BROWNS FERRY NUCLEAR PLANT UNIT 3 - REPORTABLE DEFICIENCY -
RPV STABILIZER PLATES INSTALLED INCORRECTLY - IE CONTROL
NO. HO 1340 F2

BROWNS FERRY NUCLEAR PLANT UNIT 3

RPV STABILIZER PLATES INSTALLED INCORRECTLY

FINAL REPORT

FIGURE 1

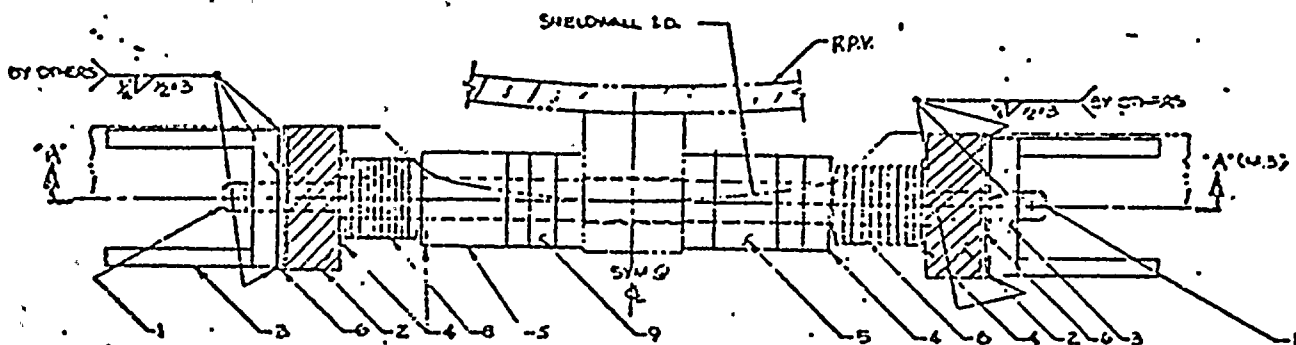
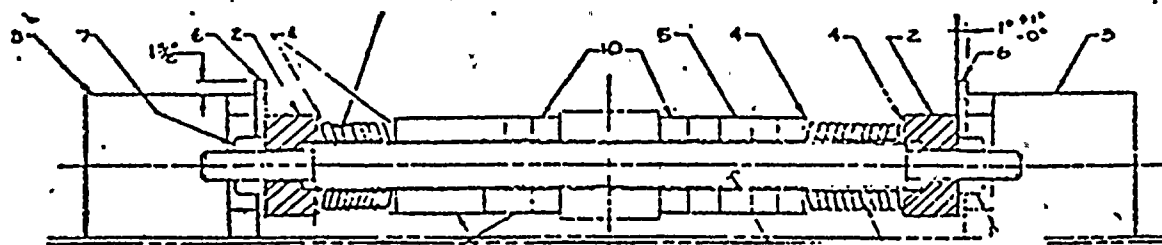
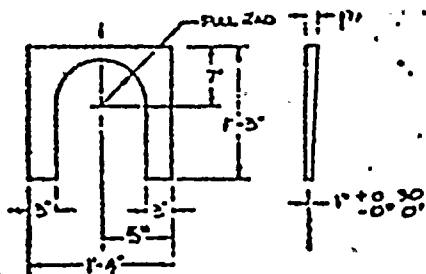
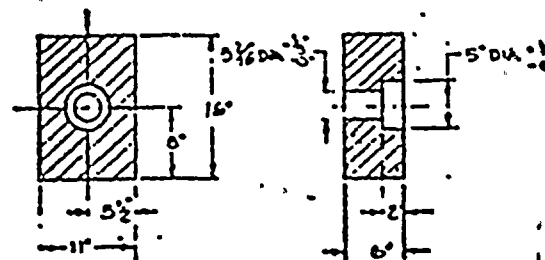
The General Electric Company released a field disposition instruction (FDI) requesting that an inspection be performed on the reactor pressure vessel (RPV) seismic stabilizers at Browns Ferry Nuclear Plant. The purpose of the inspection was to ensure the stabilizers were installed with sufficient clearances to permit relative deflections between the reactor pressure vessel and the shield wall without binding and inducing cyclic stresses in the stabilizers. When performing this inspection it was discovered that part of the stabilizer assembly had been incorrectly installed. Bearing plates at each end of the assembly had been installed 90 degrees from their intended orientation, see figure 1, attached.

The stabilizer bearing plates were originally installed rotated 90 degrees from their intended orientation.

FIGURE 2

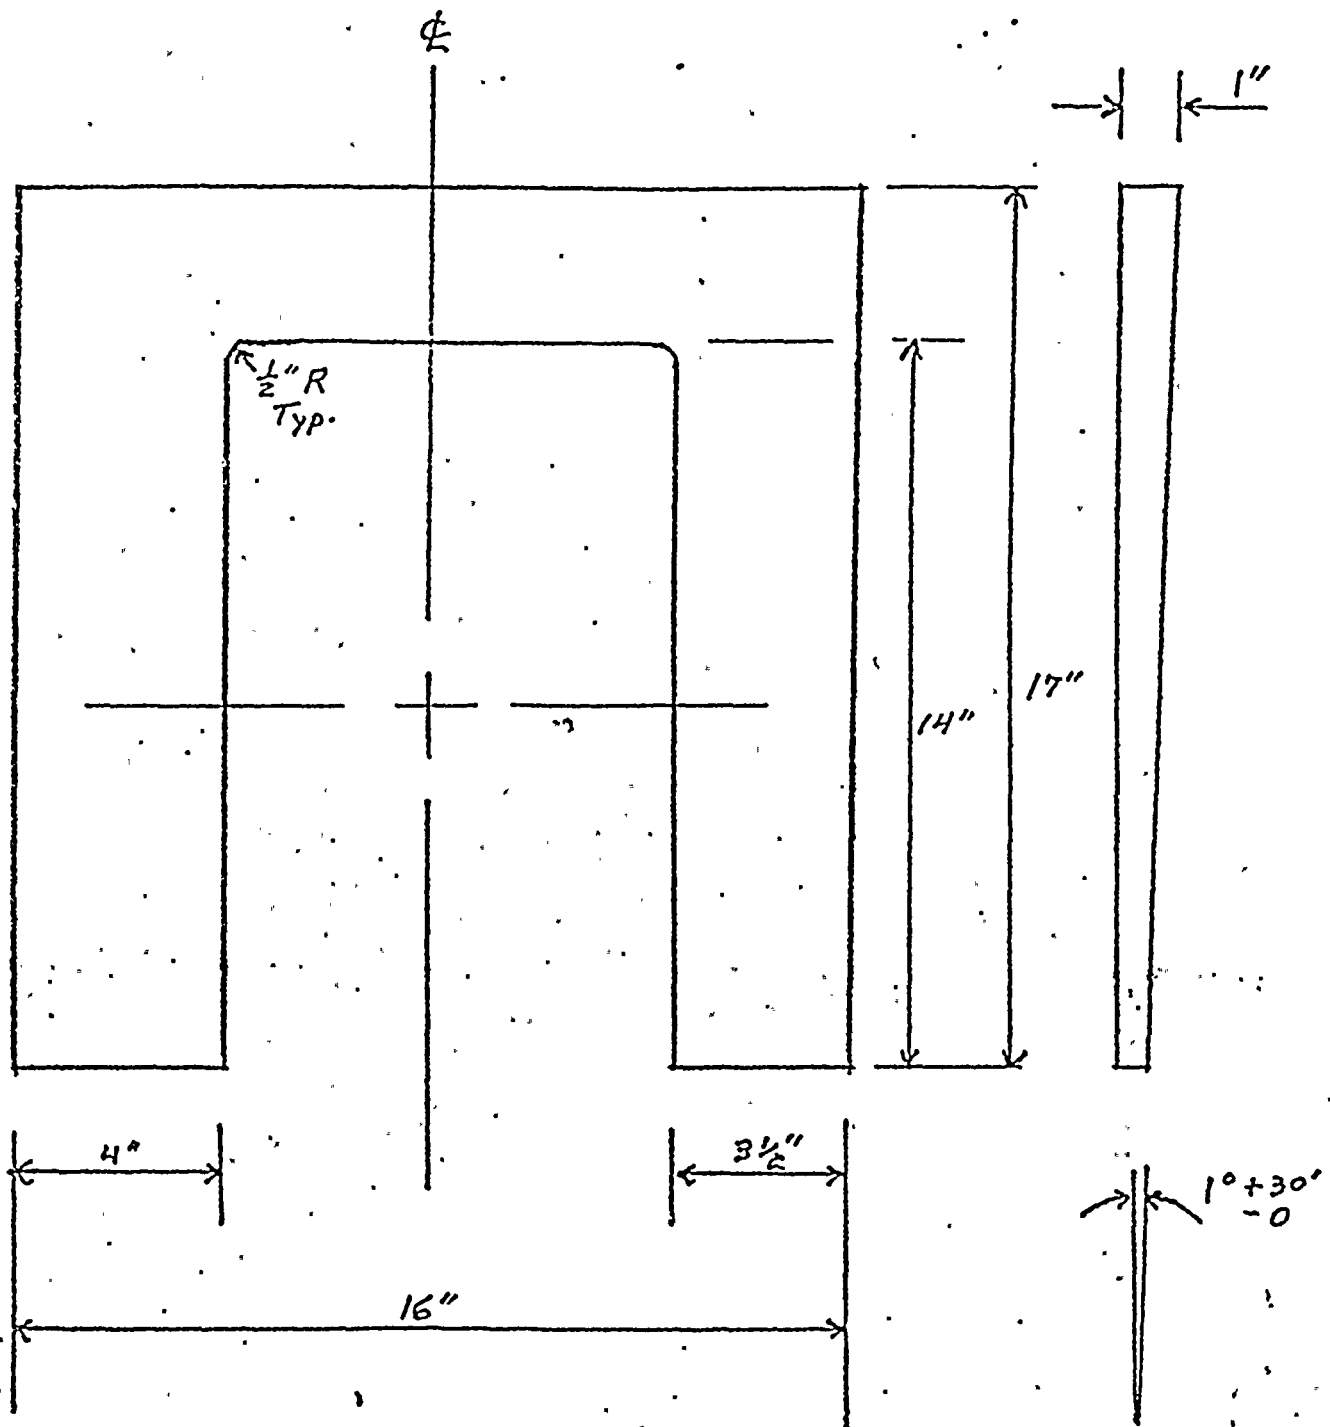
General Electric was notified of this deficiency and recommended that TVA implement one of two fixes: (1) rotate the bearing plate 90 degrees to the correct orientation, or (2) replace the shim plate on the bumper bracket with a new design of different dimensions. Since the stabilizers are fully assembled and are located in an area with limited access, rotation of the bearing plates would have been very difficult. Instead, new shim plates have been fabricated and have been installed. These new shim plates increase the amount of bearing surface area available and decrease the likelihood of a bearing plate "punching through" the shim plate cut-out (see figure 2 for new shim plate dimensions).
